Planning & Development Division
Planning & Economic Development Department

File Number	PL 21-188	Contact	Kyle Deming	
Type	Final Plat	Planning Commission Date		January 11, 2022
Deadline for Action	Application Date	December 9, 2021	60 Days	February 7, 2022
	Date Extension Letter Mailed	December 22, 2021	120 Days	April 8, 2022
Location of Subject		Northwest of intersection of Skyline Pkwy and U.S. Hwy 2 (Bayview Heights)		
Applicant	Cynthia Crawford	Contact		
Agent	Northland Consulting Engineers	Contact	David Bolf	
Legal Description		See attached		
Site Visit Date		September 9, 2021	Sign Notice Date	NA
Neighbor Letter Date		NA	Number of Letters Sent	NA

Final Plat of Skyline View Estates to subdivide 67.71 acres into 13 lots along a public street.

Staff recommends approval, with conditions.

SKYLINE VIEW ESTATES

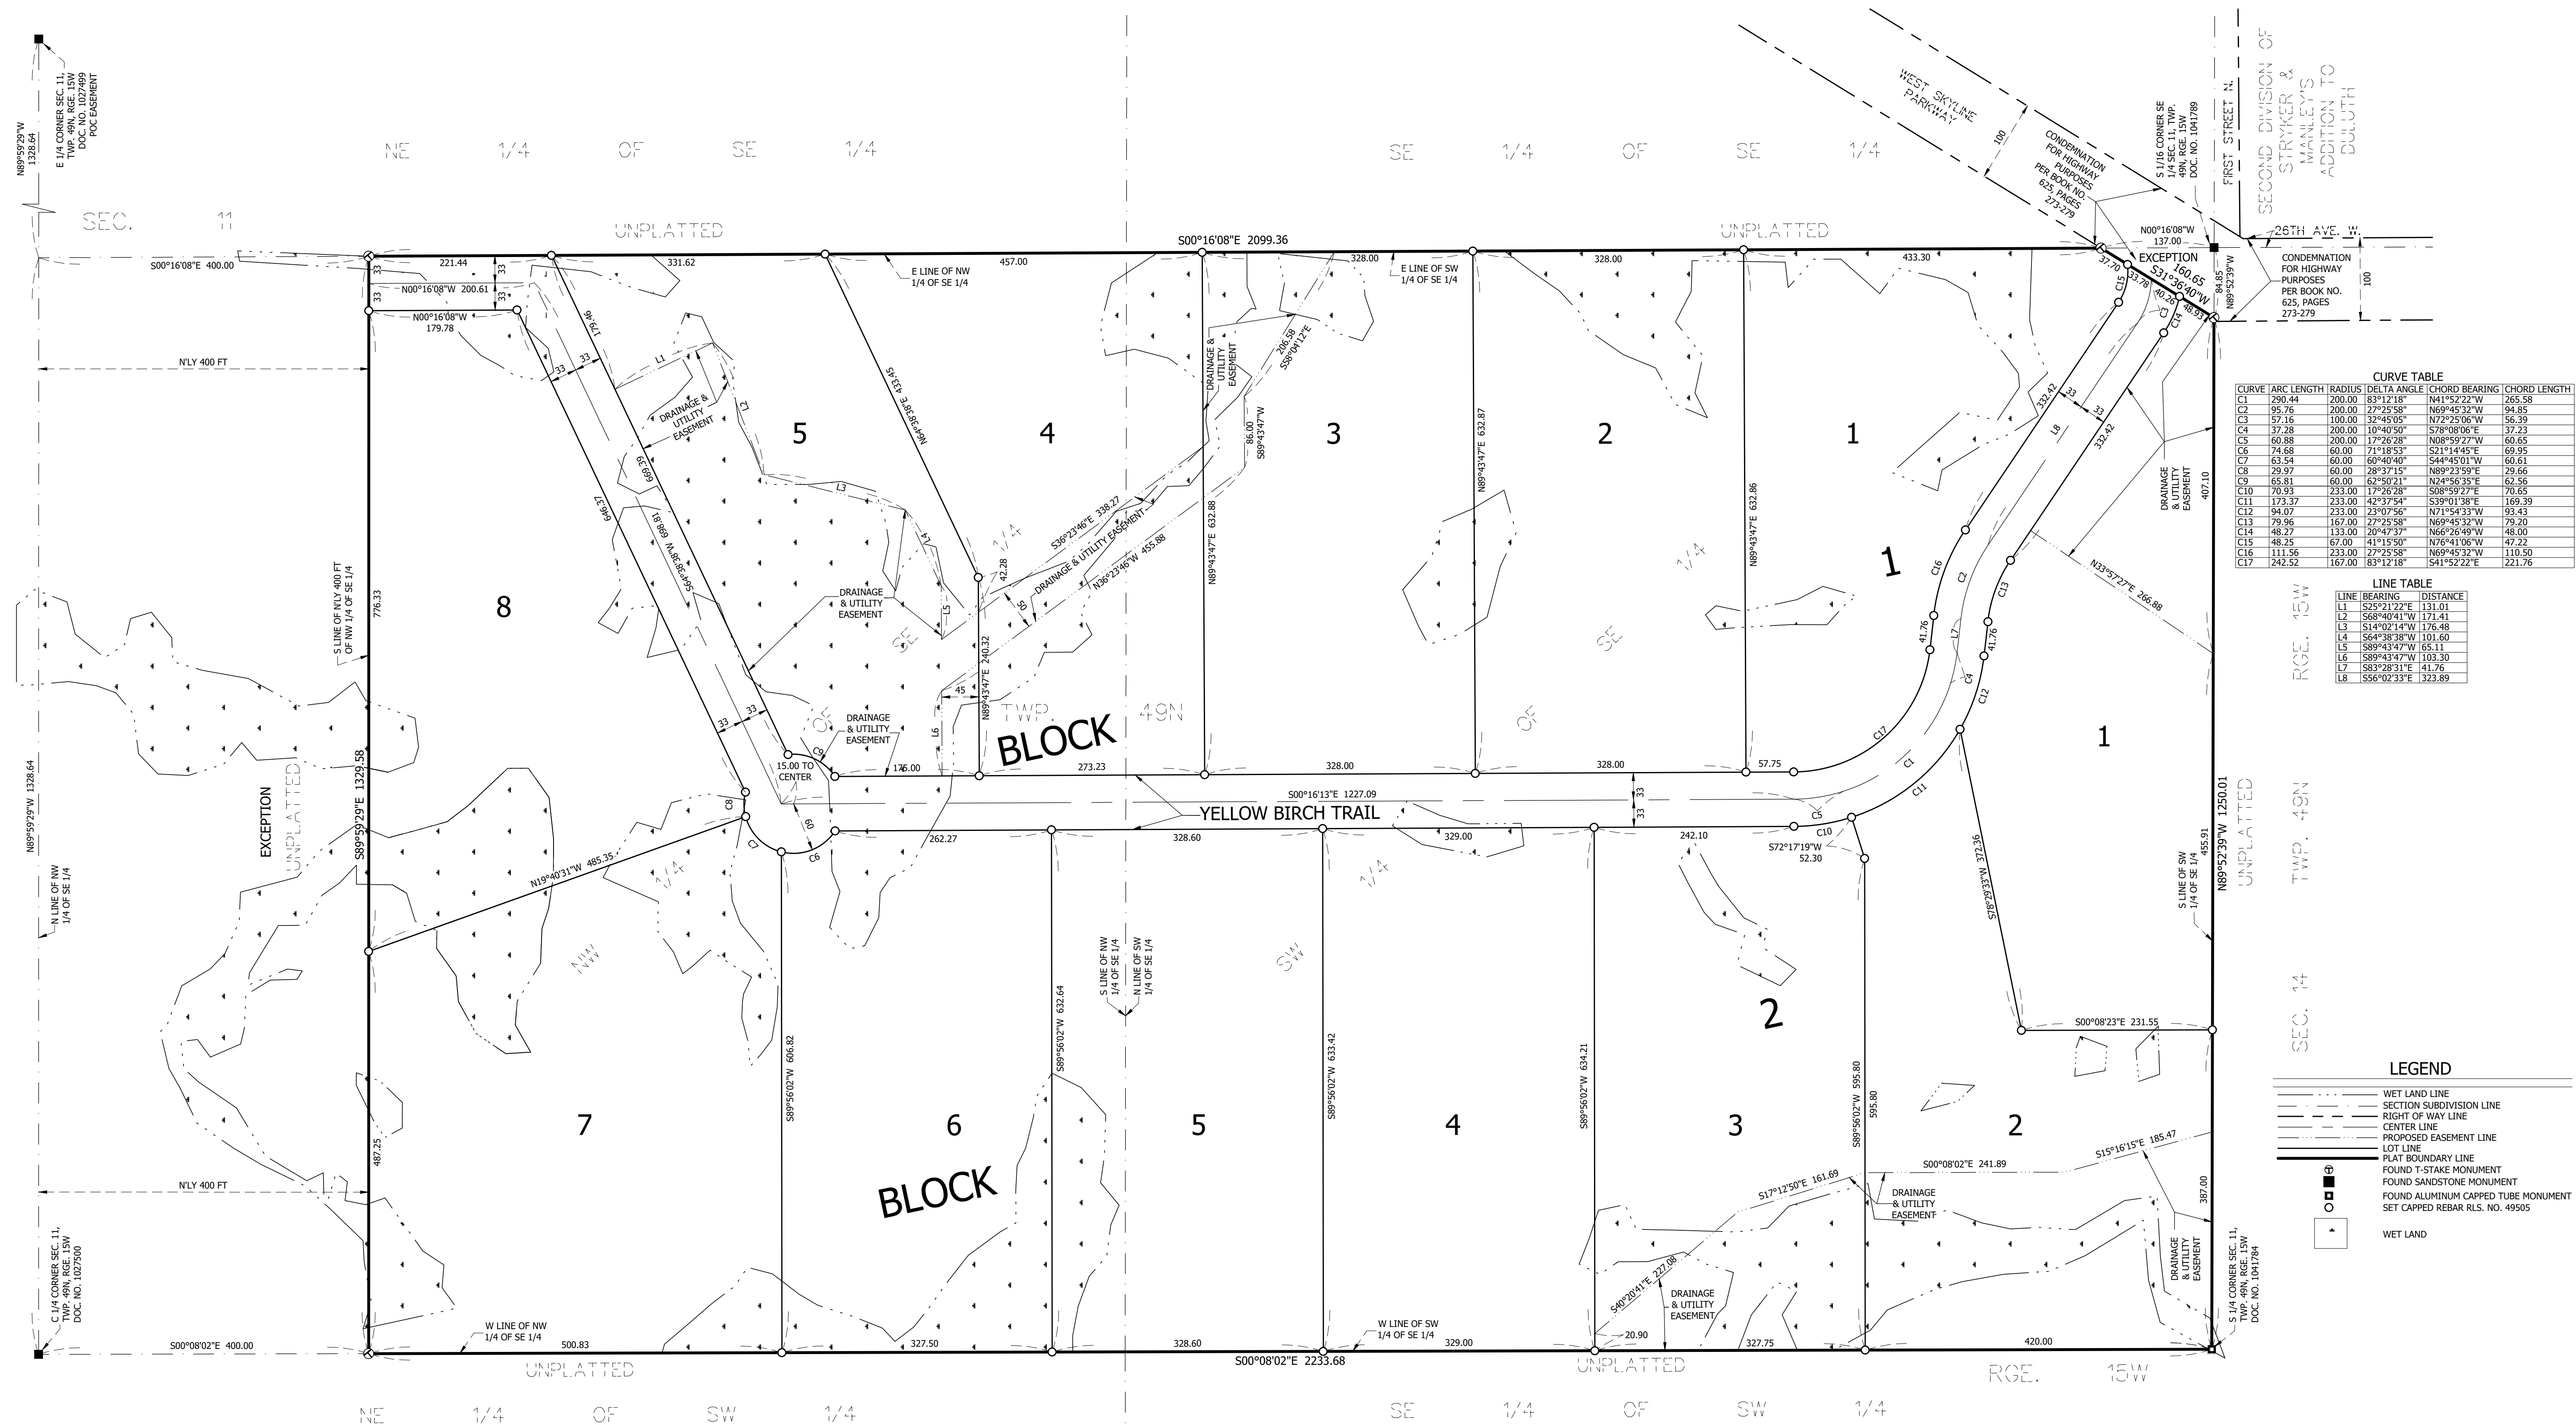
- a. Modifications to the final plat and related agreements have been made as described below:
 - i. The lot line between Lots 9 and 10 (which has been renumbered in the final plat to Lots 4 and 5, Block 1) was adjusted to provide space for a driveway that minimized wetland impacts. The portion of the wetland proposed for impact due to the driveway has been included in the wetland replacement plan application.

- ii. A drainage and utility easement has been included on Lots 2 and 3 (which are now numbered Lots 2 and 3, Block 2) and the requirement for markers has been included in the Development Agreement.

- iii. The required drainage and utility easement has been placed on Lot 9 (now numbered Lot 5, Block 1).
 - iv. The storm water basin is planned for the drainage and utility easement in Lot 1, Block 2 outside of delineated wetlands.

- v. A drainage and utility easement has been established on Lots 10 and 11 (now numbered Lots 3 and 4, Block 1) and the requirement for markers has been included in the Development Agreement.

PRELIMINARY PLAT OF SKYLINE VIEW ESTATES

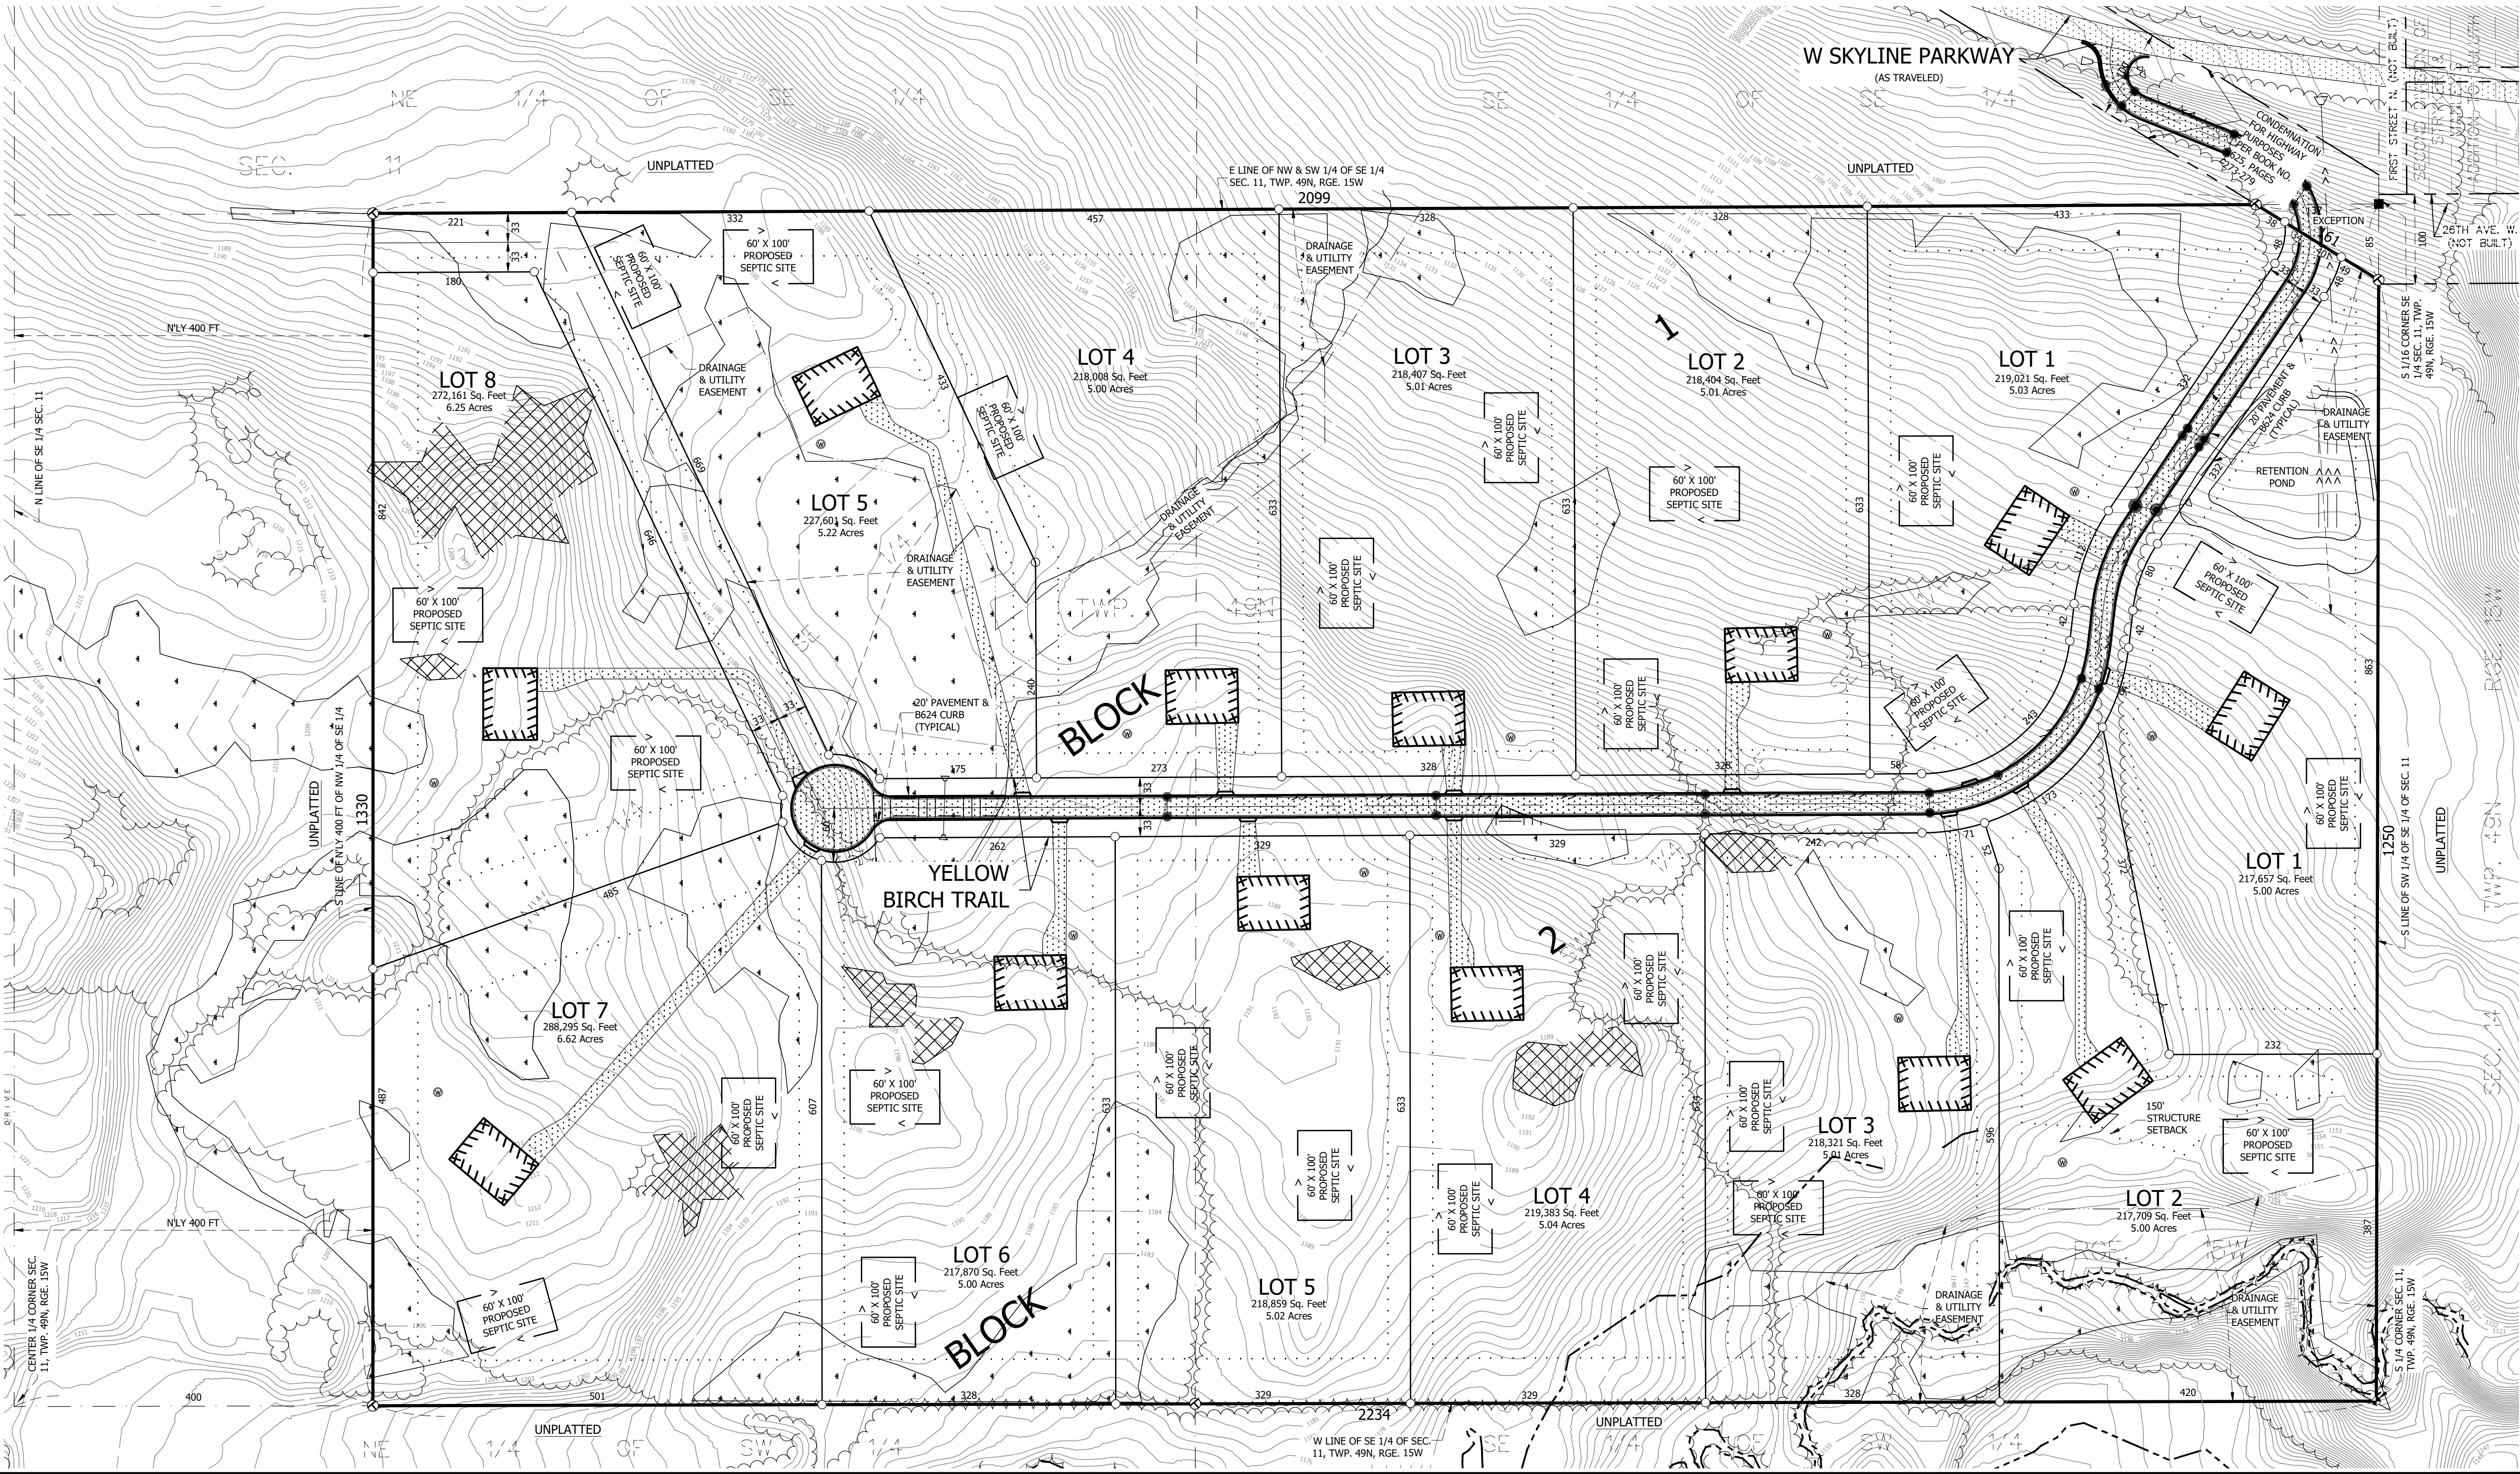
- b. The final plat shall be drafted with modifications to the following elements depicted on the preliminary plat:
 - i. The proposed driveway serving Lot 9 shall be relocated, either through modification to the lot line between Lot 9 and Lot 10, or through alternate means, to avoid wetland impacts resultant through construction of said driveway.

- ii. Drainage and utility easements shall be provided consistent with UDC requirements for shoreland protections to ensure the preservation of natural vegetation near Kingsbury Creek along Lots 2 and 3. Permanent metallic markers on rigid metal posts shall be placed at the location of shoreland setbacks indicating that all natural vegetation between the permanent markers and the creek is to remain in a natural state.

- iii. Drainage and utility easements shall be established over no less than 90% of the wetlands existing on Lot 9.
 - iv. Stormwater ponds are currently depicted on Lots 1 and 13 on the submitted "Stormwater Concept Plan." All stormwater ponds shall be redesigned to be located fully outside wetland areas, including those wetlands on Lot 13.

- v. Drainage and utility easements shall be provided consistent with UDC requirements for shoreland protections for the drainage way between Lots 10 and 11, which provides for the uplands for creeks referenced in the stormwater plan. Permanent metallic markers on rigid metal posts shall be placed at the location of shoreland setbacks indicating that all natural vegetation between the permanent markers and the creek is to remain in a natural state.
